MEMORANDUM

**To:** Montgomery Township Planning Board  
**From:** Michael Sullivan, ASLA, AICP  
Emily Goldman, PP, AICP  
*Emily Goldman*  
**Re:** **Caivano Residence**  
**Minor Subdivision and Bulk Variances**  
243 & 257 Hollow Road  
Block 12001, Lots 14 & 16  
R-5 Residential Zone  
**Date:** April 19, 2021, last revised March 11, 2022

Re: Caivano  
257 & 243 Hollow Road  
Montgomery Township  
Somerset County, New Jersey  
Block 12001, Lots 14 and 16  
**Minor Subdivision, Lot Line Adjustment**  
**Bulk Variance**  
**Review #3**  
Application #PB-10-20

To: Montgomery Township Planning Board  
From: Lauren A. Wasilauski, Open Space Coordinator  
Date: March 9, 2022  
Re: PB-10-20: Wayne & Betsy Caivano  
Block 12001 Lots 14 & 16  
257 Hollow Road, Skillman  
Minor subdivision with variance

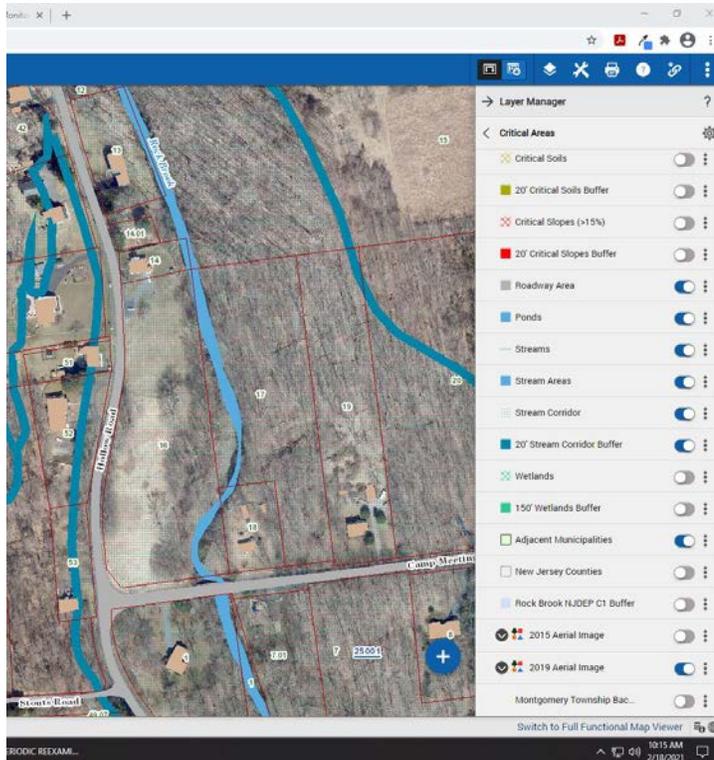
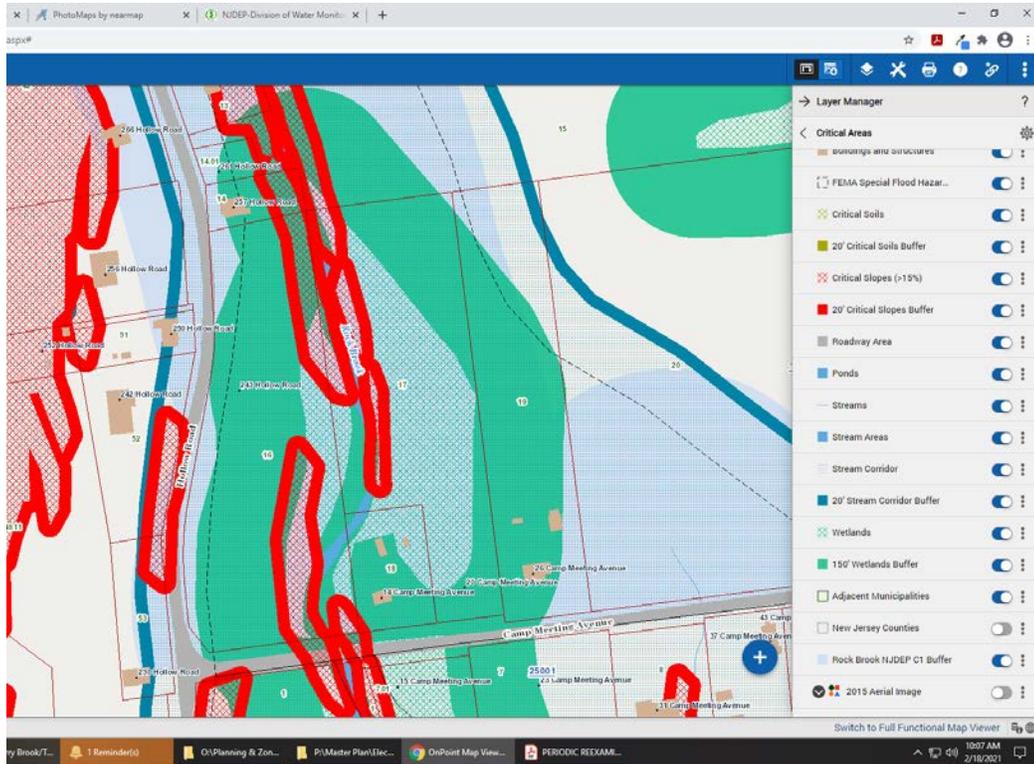
- 1. At the May 3, 2021 Planning Board meeting, the Board directed the applicant to pursue a lot line configuration that created a more regular shape for proposed lots 14.02 and 16.01. On the revised plan submitted for this hearing, the proposed common lot line between lots 14.02 and 16.01 now has multiple jogs, and is a more irregular shape than what was proposed at the May 2021 hearing. Proposed lot 14.02 is now smaller in size. The applicant should explain why these changes were made, in contradiction to the direction from the Board.
  - a. This proposed configuration will create difficulty for a future property owner in understanding where their lot lines are located in the field. A more regular configuration should be explored such as the examples illustrated below.

**F. Critical Areas; Threatened & Endangered Species**

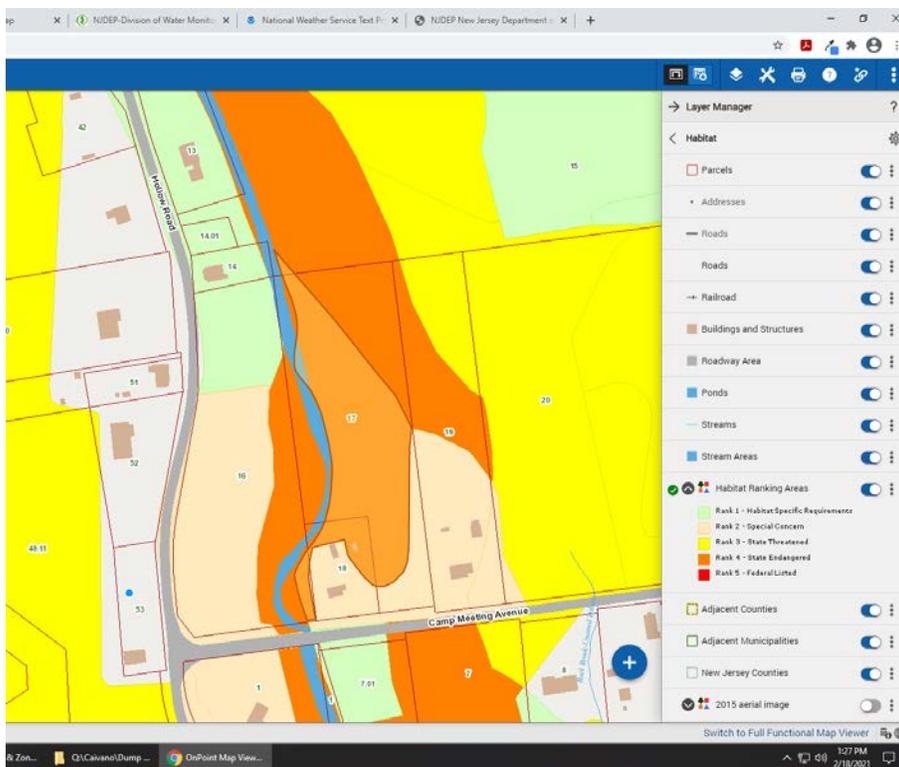
- b. The applicant is requesting a waiver of the tree planting requirement.
  - c. According to NJDEP infrared photography and Township mapping, the entirety of the site is impacted by one or more critical areas, including Township stream corridor, assumed wetlands and associated buffer areas, steep slopes and associated buffer. The property lies entirely within the Rock Brook Category One stream buffer (see map on following page).

- d. Based upon area of disturbance of 2,400SF, the applicant should plant 1 (one) tree on the property, preferably in the stream corridor, as compensation for the area to be disturbed by the septic system installation.

**PEDESTRIAN-BIKEWAY  
CORRIDOR PLAN**  
November 2001

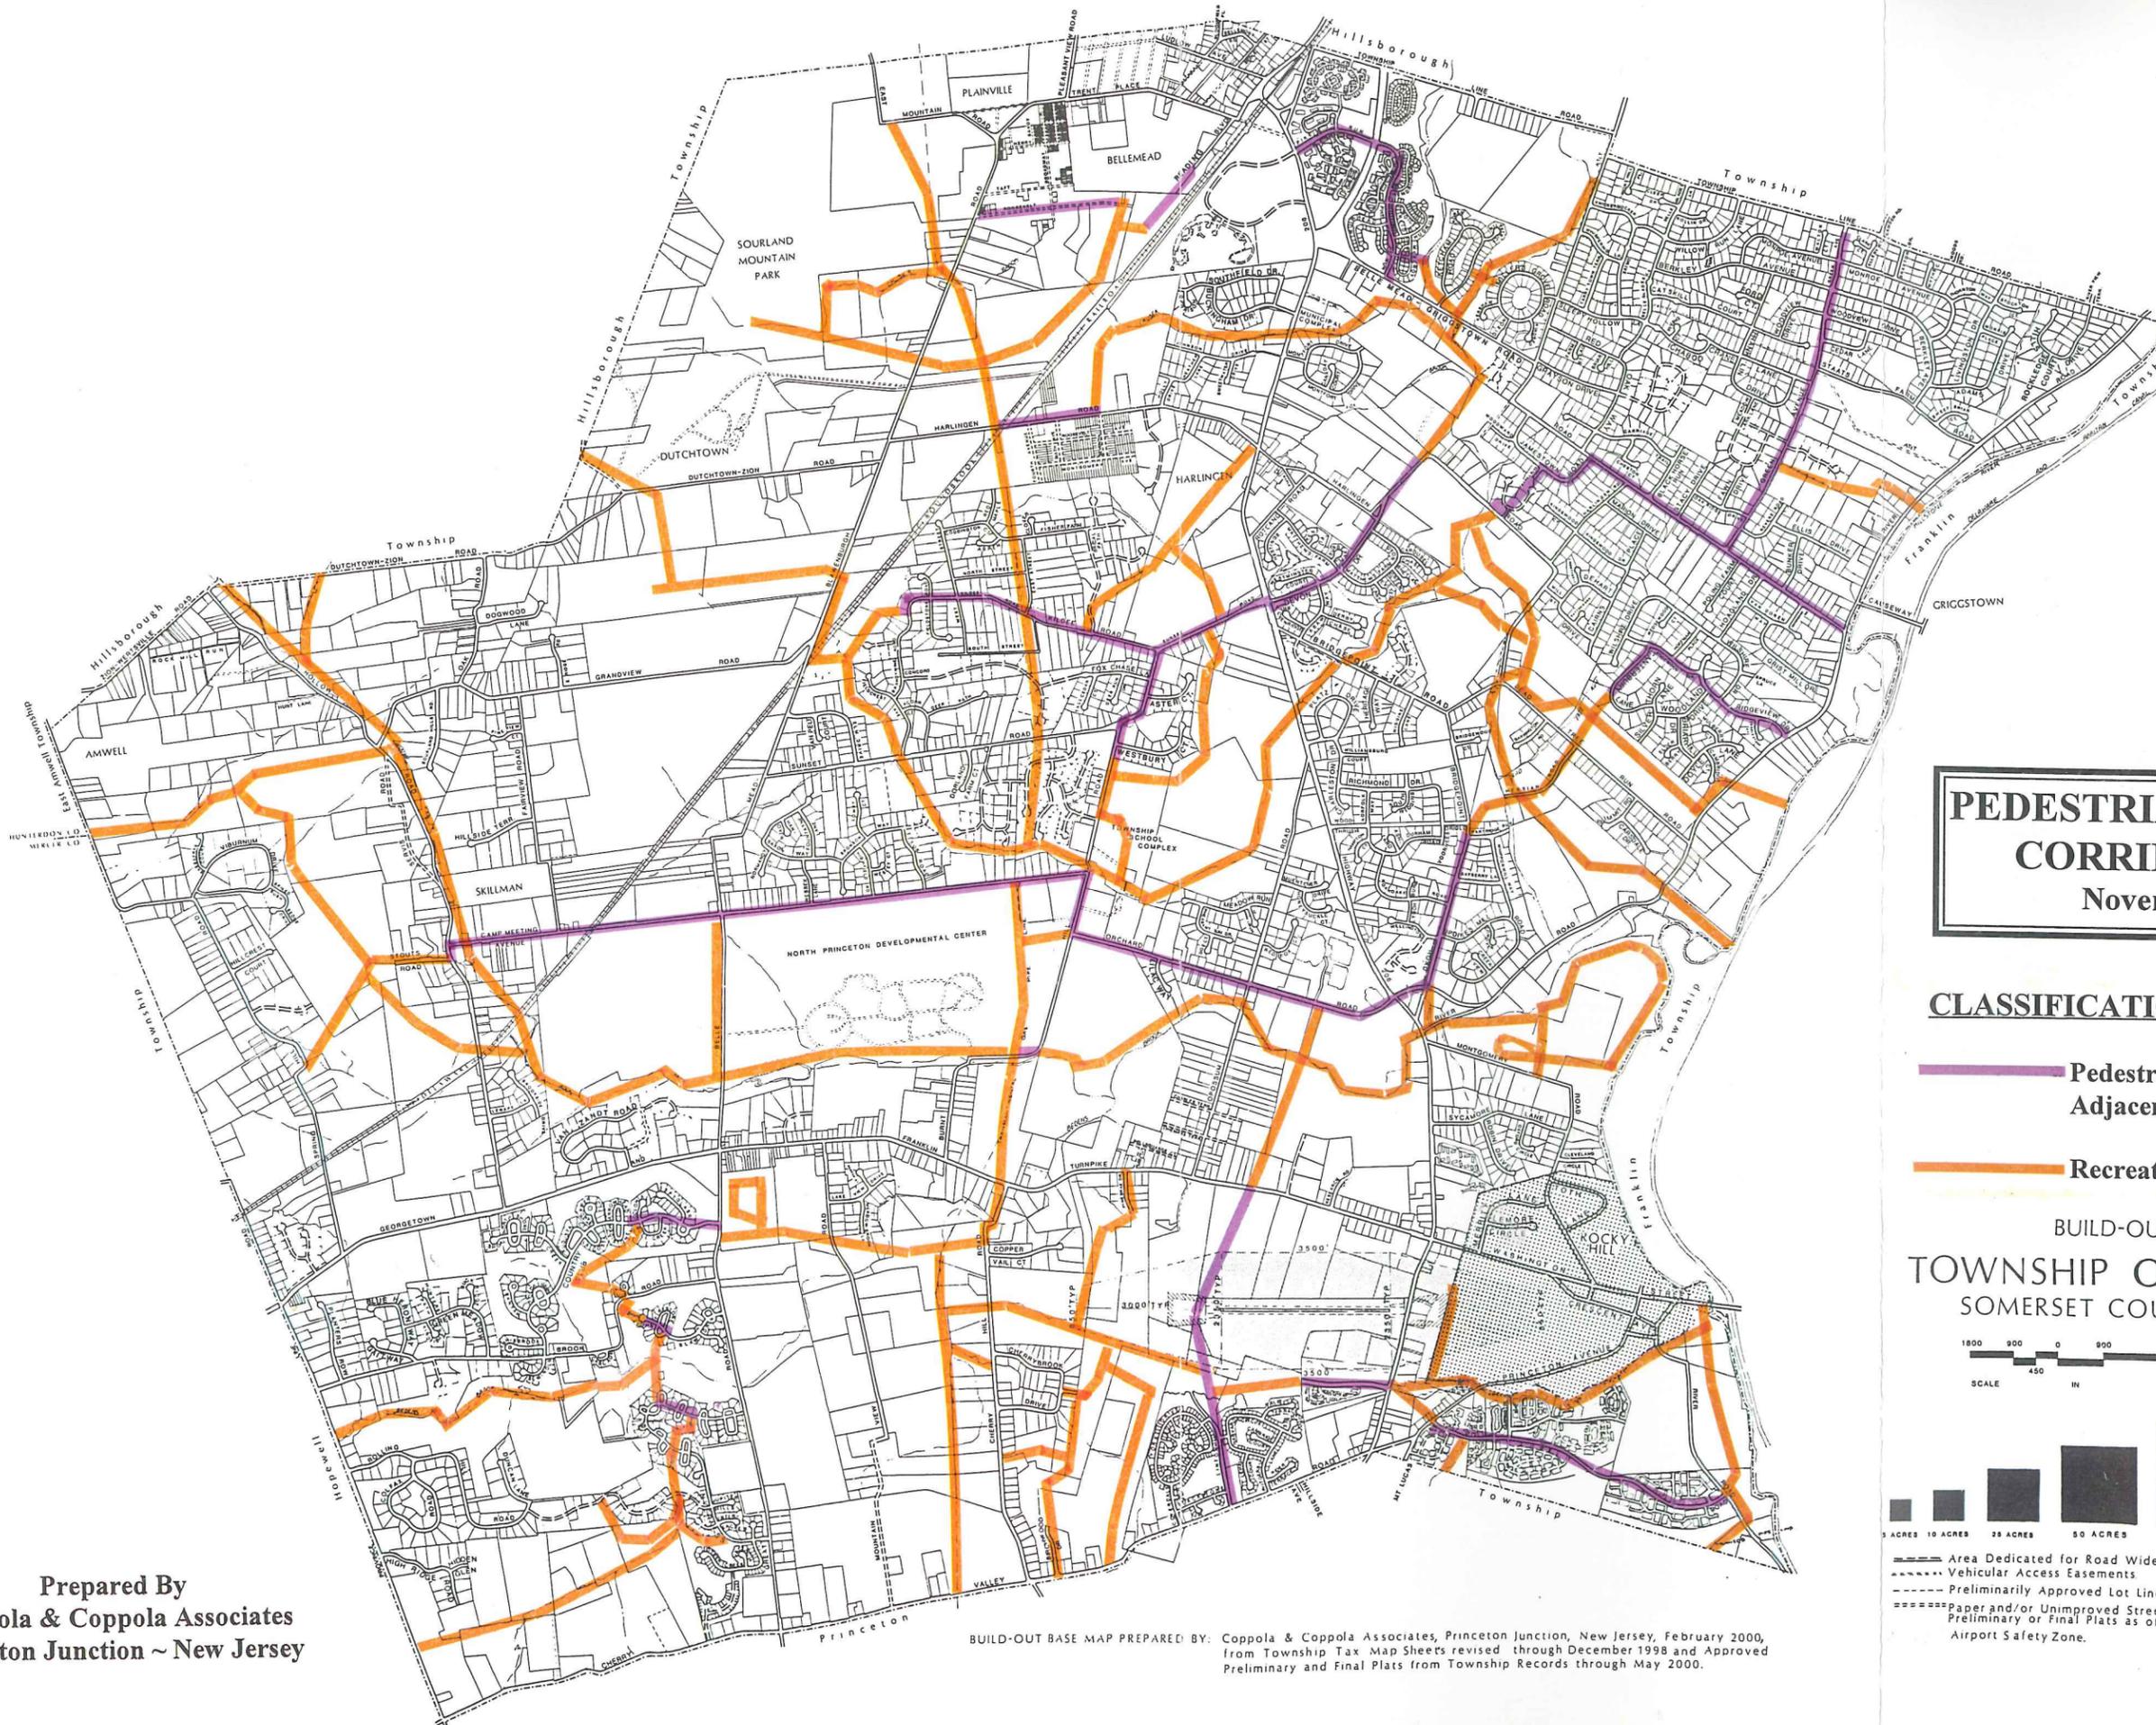
1. Township Code Section 16-5.14C requires sidewalks along all public roadways, except in the MR zoning district.
2. The applicant's plans do not propose any sidewalks.
3. This office defers to the Township Engineer on whether a right of way dedication is needed on Camp Meeting Avenue to accommodate a future sidewalk in this location. A sidewalk along

Camp Meeting Avenue is indicated on the Pedestrian-Bikeway Corridor Plan (attached). The Township is actively engaged in constructing pathways in the vicinity.
